Title: Advisory Committee on Reactor Safeguards
 Regulatory Policies and Practices

Date: Monday, September 16, 2013

- ACRS comments on MACCS2 weather uncertainty integration and convergence of results, and staff responses
- MELCOR parameters of interest
- MACCS2 parameters of interest

MELCOR – MACCS2 – Weather Uncertainty Integration

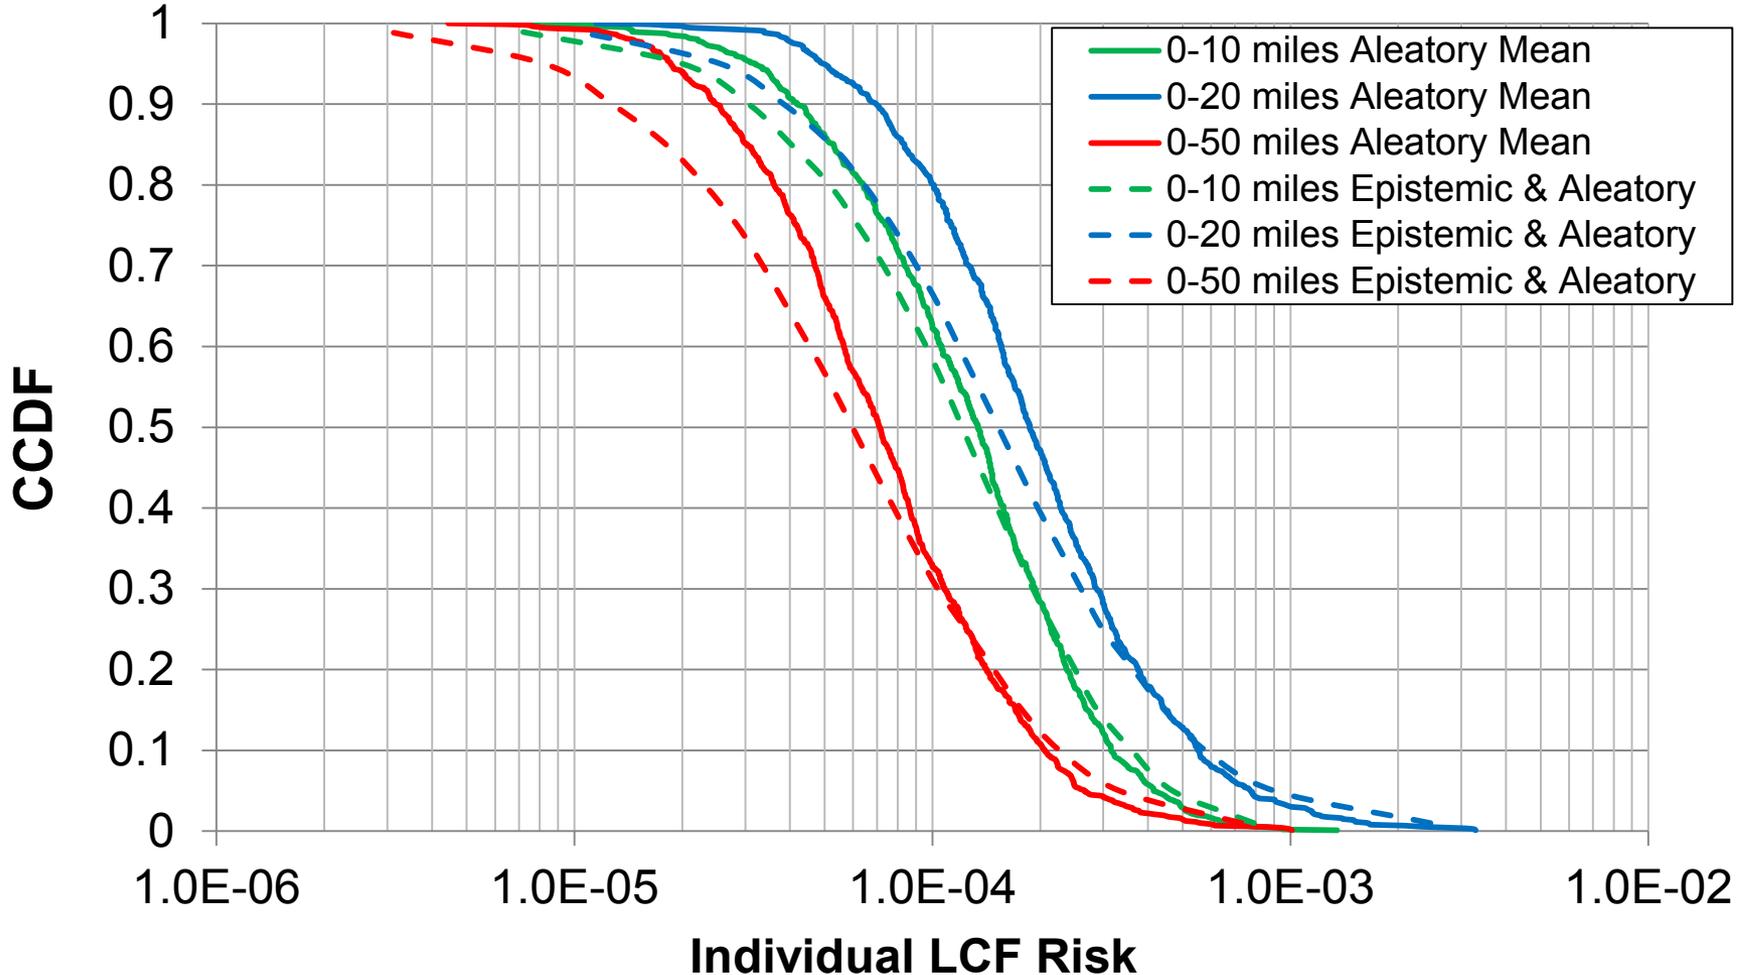
ACRS Comment:

- For the combined MELCOR-MACCS2 results, the report currently presents only results averaged over the weather trials.
- The report should also present results that include and display the full weather aleatory uncertainty

Runs 3-5 and Run 1 Conditional, Mean Individual Prompt Fatality Risk (per Event) Epistemic Uncertainty CCDF, at 1.3 Miles

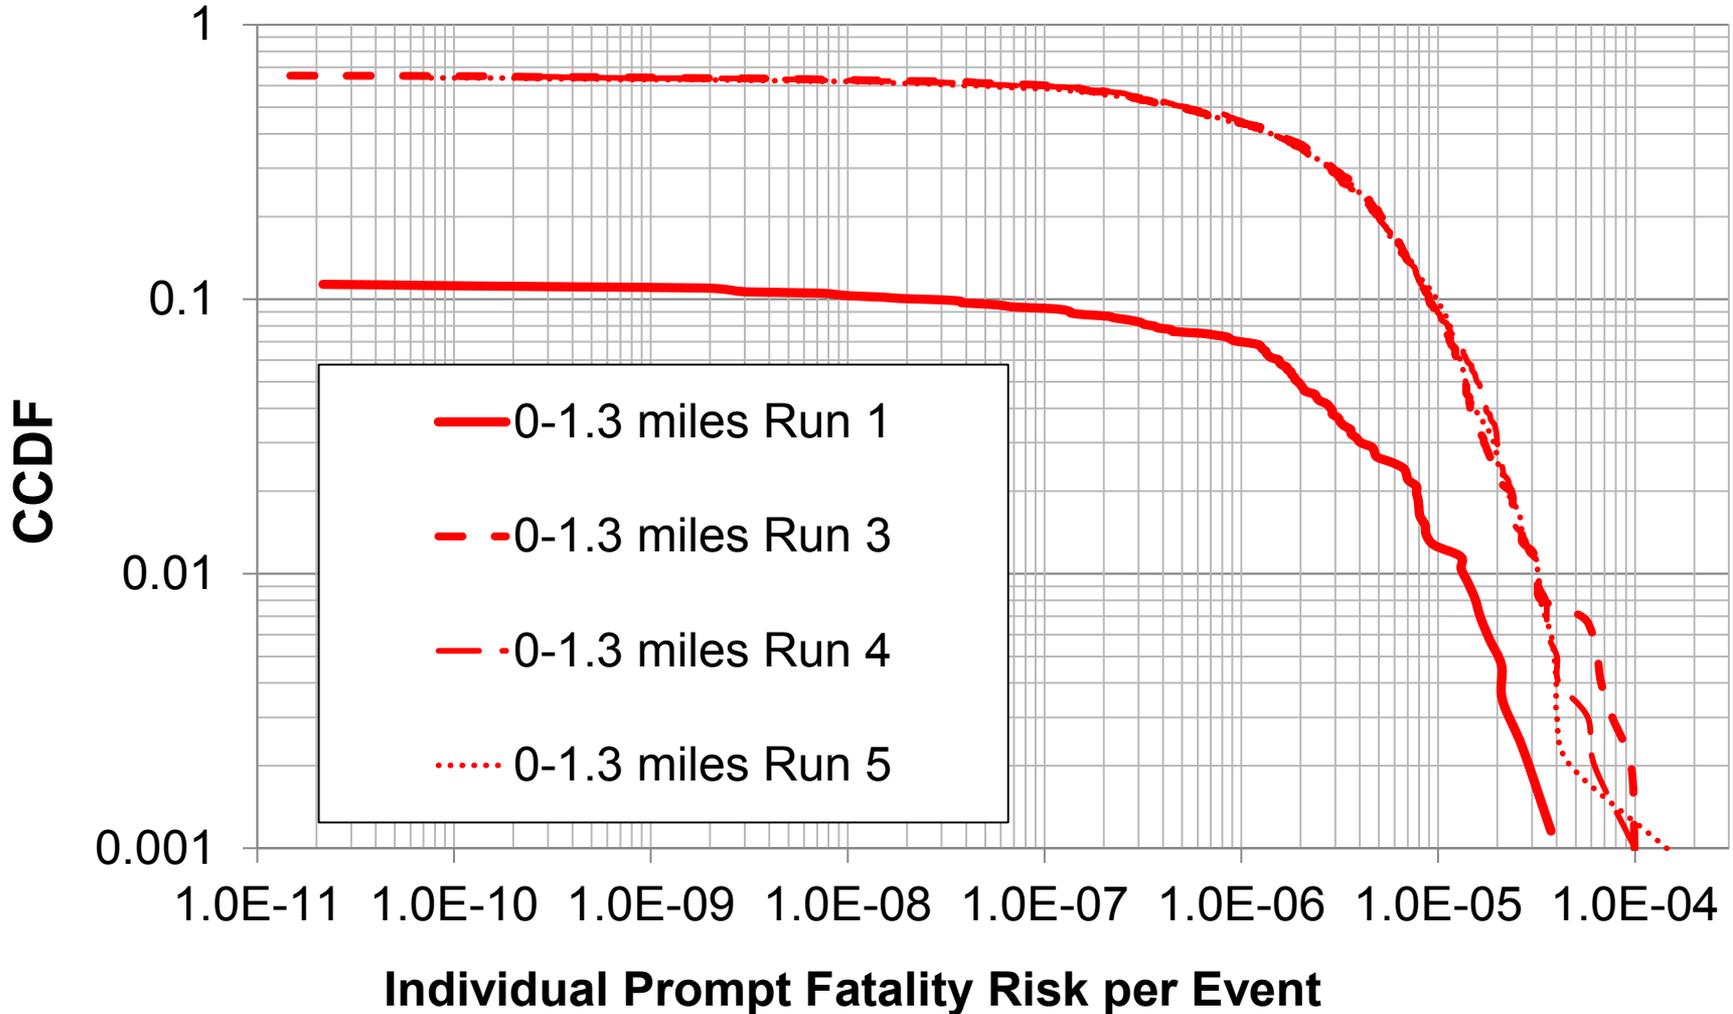
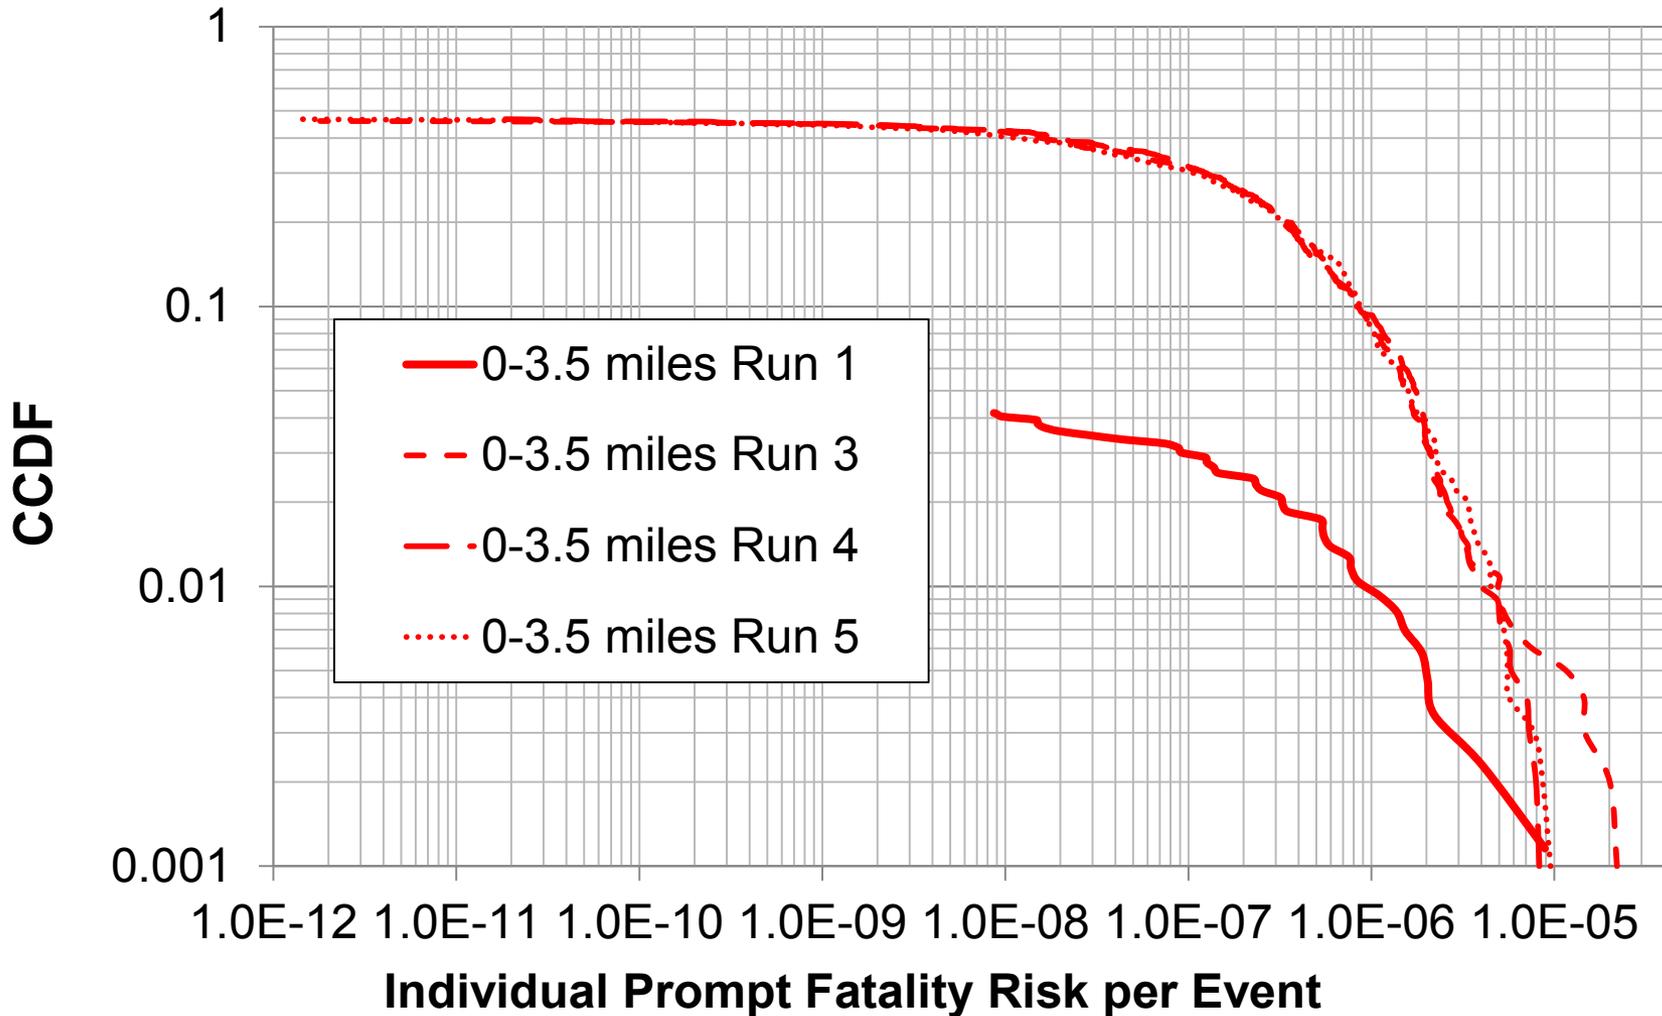
22 DR. GHOSH: Okay. So on slide six is the
23 next comment or maybe a suggestion I should call it, which
24 was to select the MELCOR realization that produced the
25 largest conditional prompt fatality consequence in our

ACRS Comment:

Run 6-8 Combined Aleatory and Epistemic Uncertainty Conditional Individual LCF Risk (per Event) CCDF

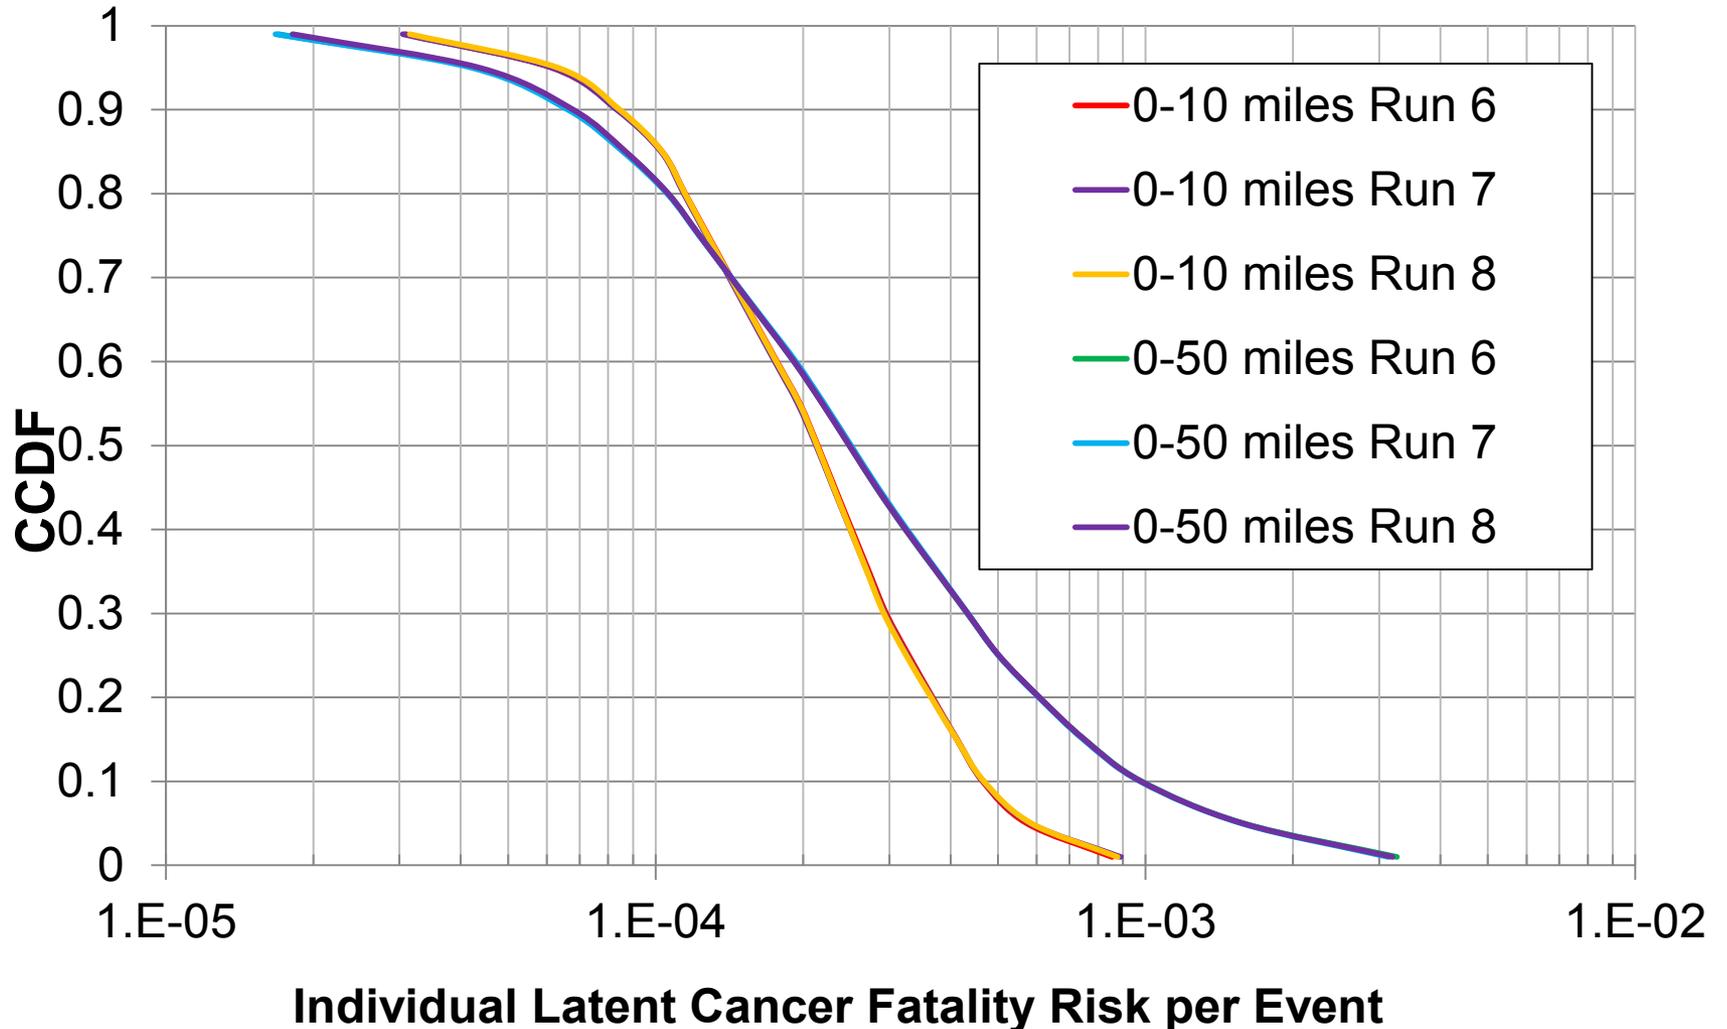
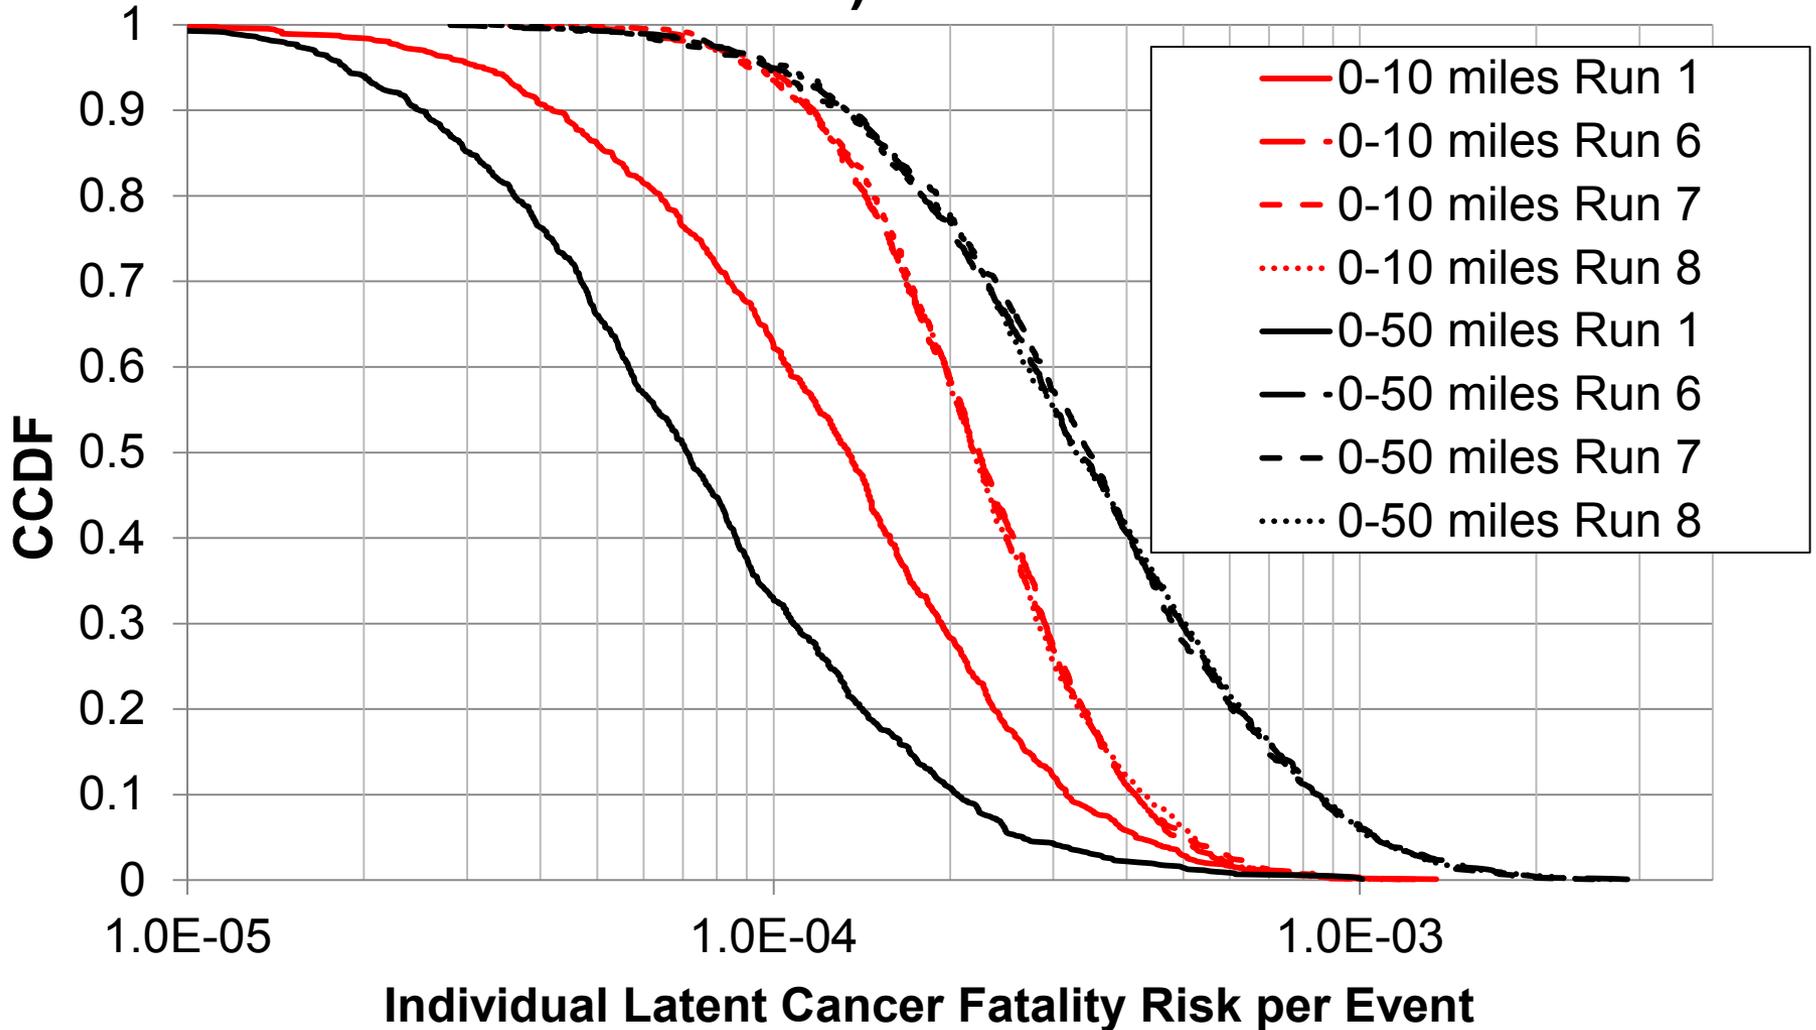
23 CHAIRMAN STETKAR: I found it useful to
24 look at - if any of the subcommittee members have Figure
25 10 in the material that you sent us which does plot Run

ACRS Comment:

Approach:

- MELCOR Replicate 3, Realization 46 identified as the source term that produced the largest conditional LCF risk consequence
- For that source term, three Monte Carlo runs of sample size 1000 were completed (Runs 6, 7, 8) using three different LHS random seeds for the 350 MACCS2 input parameters
- The same 984 weather trials were used
